LETTER AND RESPONSE TO REGULATOR COMMENTS ON UFP SAMPLING AND
ANALYSIS PLAN PHASE I RCRA FACILITY INVESTIGATION SOLID WASTE MANAGEMENT
UNIT 21 (SWMU 21) FORMER DRMO STORAGE LOT NSA CRANE IN
3/23/2010
TETRA TECH

**Response-to-Comments (RTC) Document
On
Uniform Federal Policy-Sampling and Analysis Plan (UFP-SAP) for
Phase I RFI at SWMU 21 – Former DRMO Storage Lot at NSA Crane**

**Comments Received from US Navy on February 24, 2010
On Internal Draft version issued on November 6, 2009**

**RTC Prepared by Tetra Tech NUS, Inc.
Date Issued: March 23, 2010**

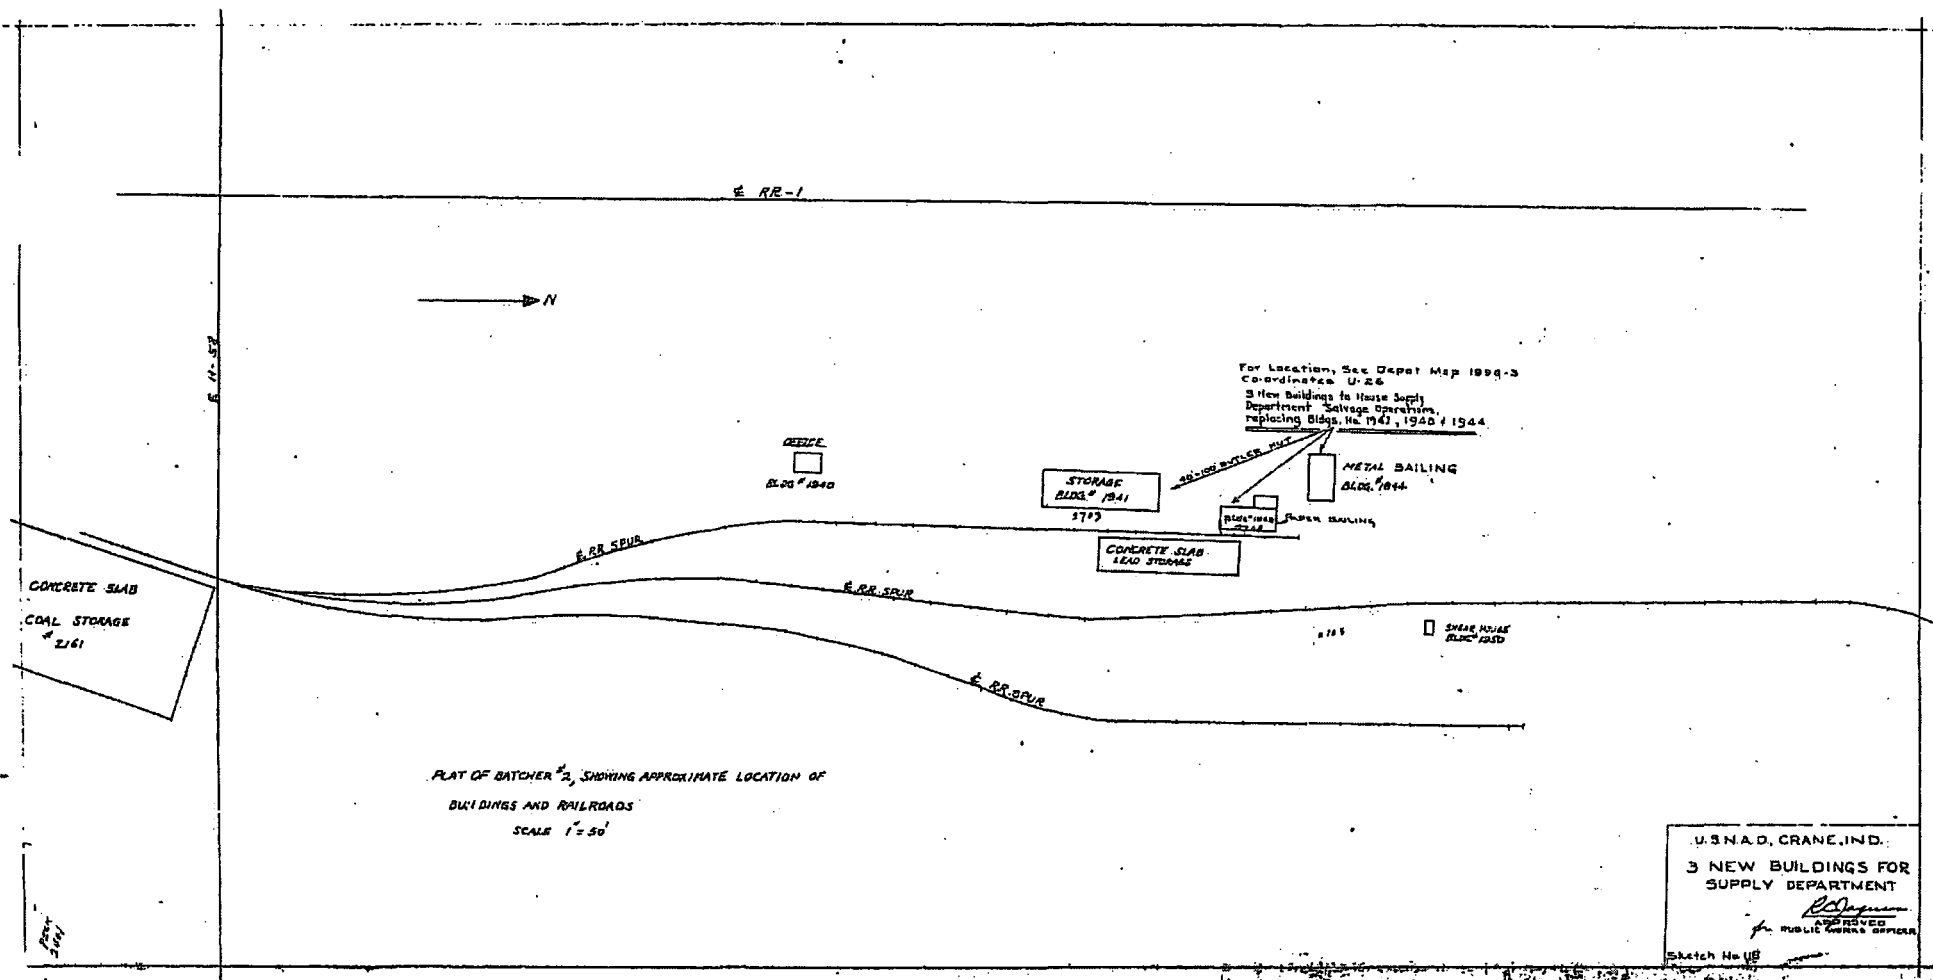
14. Worksheet 17, Soil Sampling (Phase I and Phase II), IA 6 – Open Grass Area

Comment: There are actually 2 culverts. The northern culvert is located near IA601 on Figure 17-2.

Response: *Soil samples for IA 6 will include samples from the outlet area of each of the two culverts to Haynes Branch. The text has been revised as follows:*

Based on the CSM, six surface soil samples will be collected from IA 6 at approximately 200-foot intervals. This will include surface soil samples at the outlet areas of the two culverts to Haynes Branch.

U. S. NAVAL AMMUNITION DEPOT
REVISIONS TO
METAL BAILING BLDG
NO. 1944

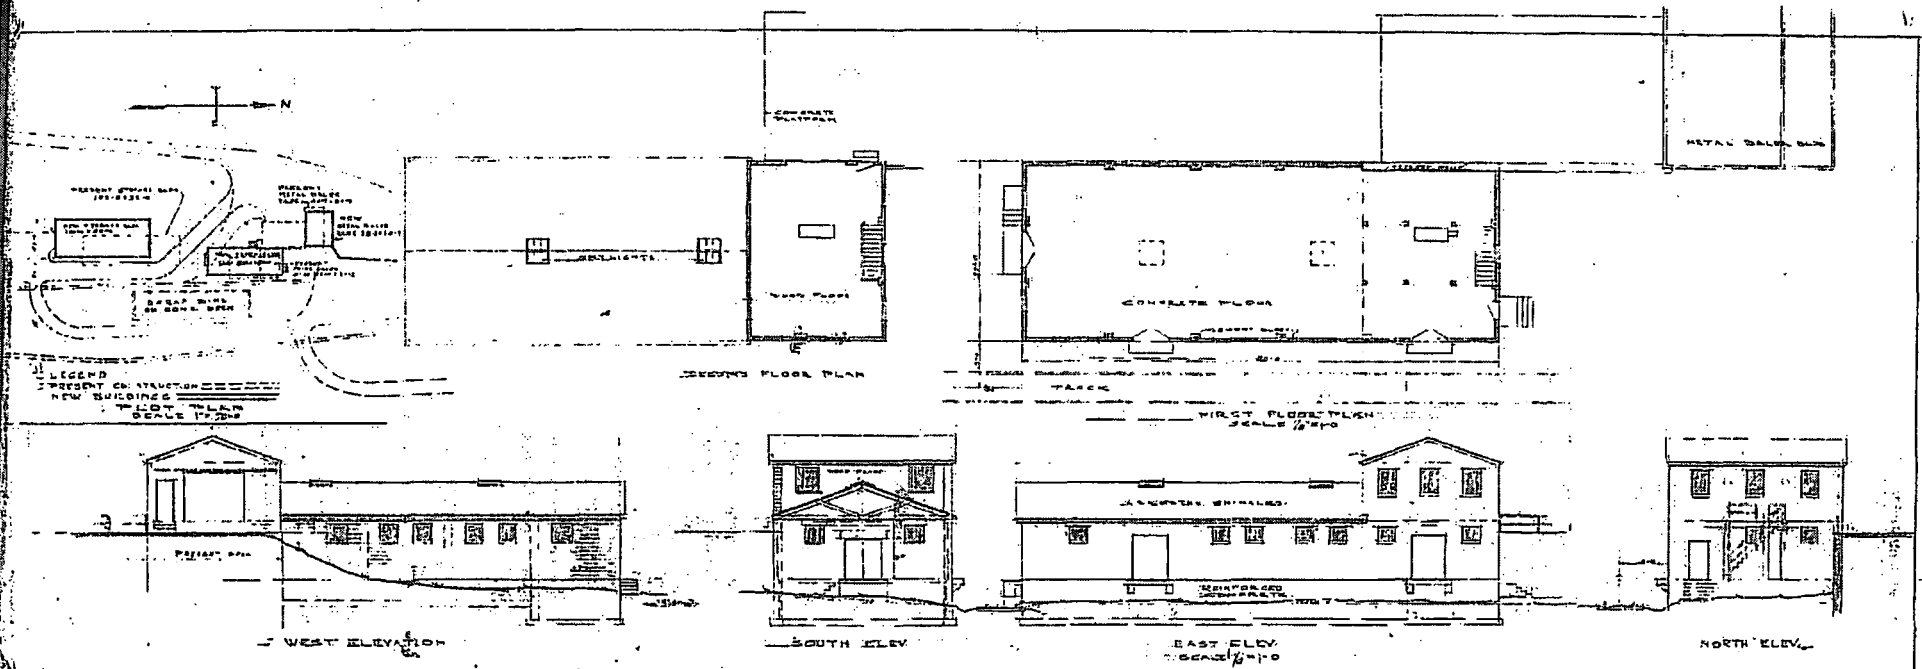
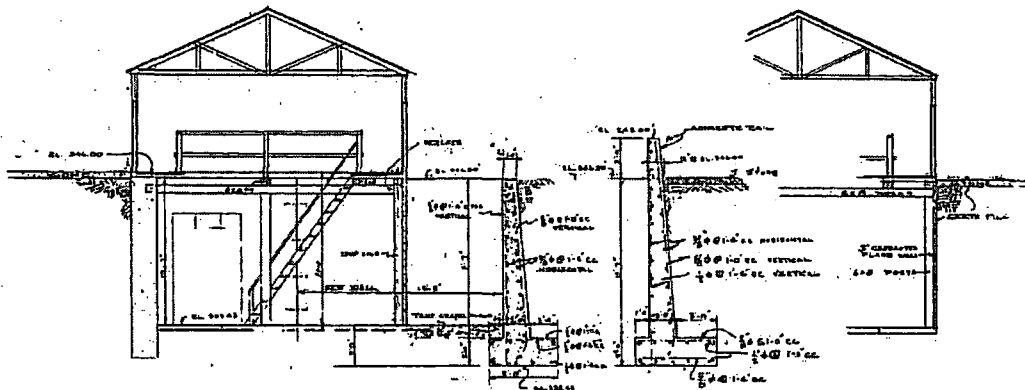
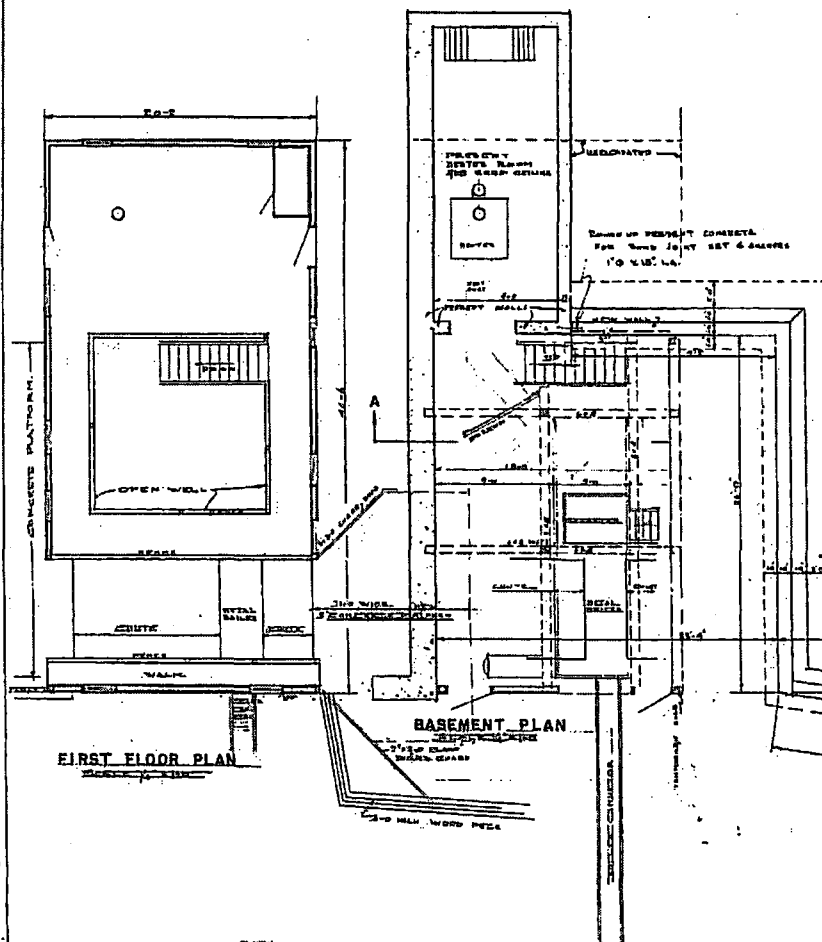
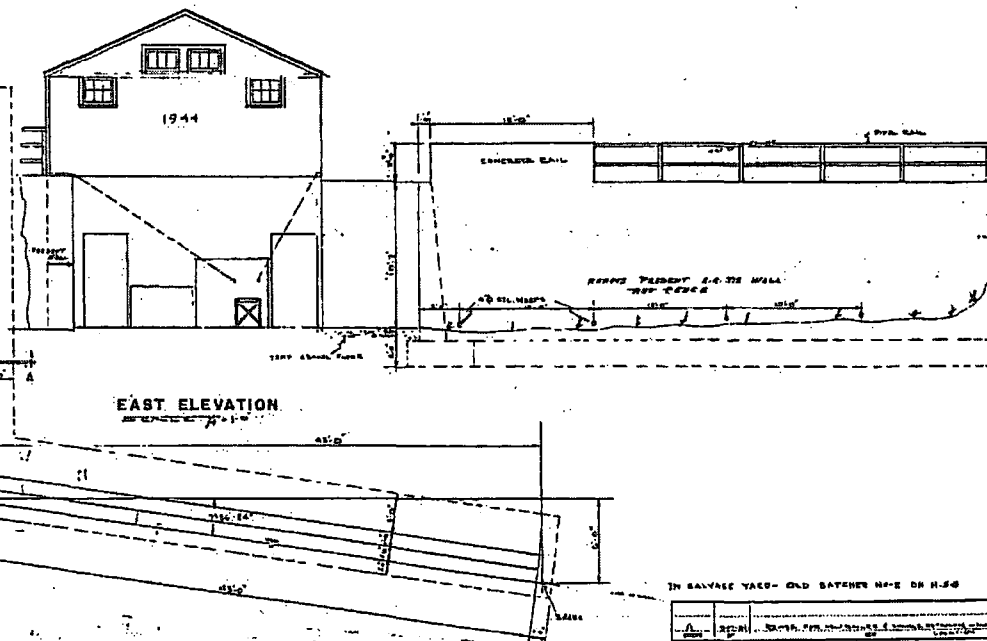
13. Worksheet 17, Soil Sampling (Phase I and Phase II), IA 4 – Original Metals Baler

Comment: B2704 was the old paper baler. Please double-check the source of this information.

Response: *The Original Metals Baler (Former Building 1944) was described as being located north of current structure 2704 (Old Paper Baler) prior to its removal in 1951/1952, as stated in WS 10.2, paragraph 3. A copy of drawings showing Building 1944 are attached to this RTC document.*
